Amphenol PCD

Engineering Change Request		ECR Number	R09451	
Initiator:	Flame	Date:	2025/08/25	
Part number description				
Item	K3 Code material part numbers	Drawing/ Doc Number	Version of current related document	New Version
	See attachment	See attachment	See attachment	See attachment

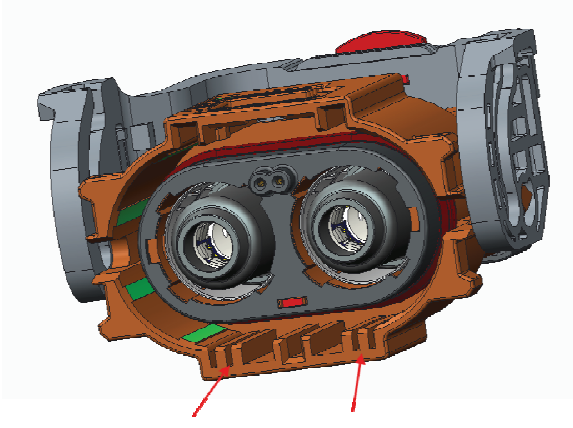
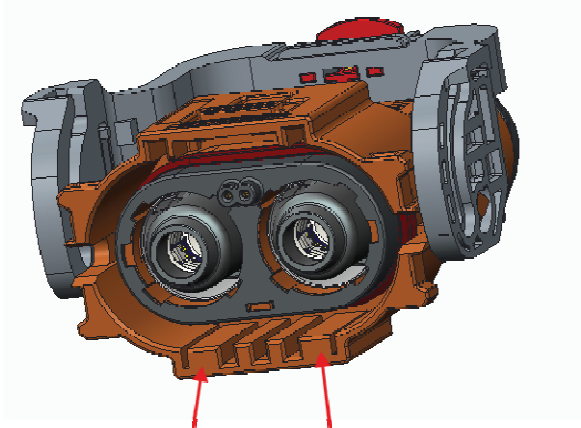
To enhance the poke-yoke effect of the HVSL800 2-core series products, increase the rib wall thickness at the A, B, and C key positions of the plug. The post-adjustment product will not affect other performance metrics and will maintain compatibility between old and new materials. The keyway fit before and after the change is as follows:

Before KEY A

After KEY A

Before KEY B

After KEY B
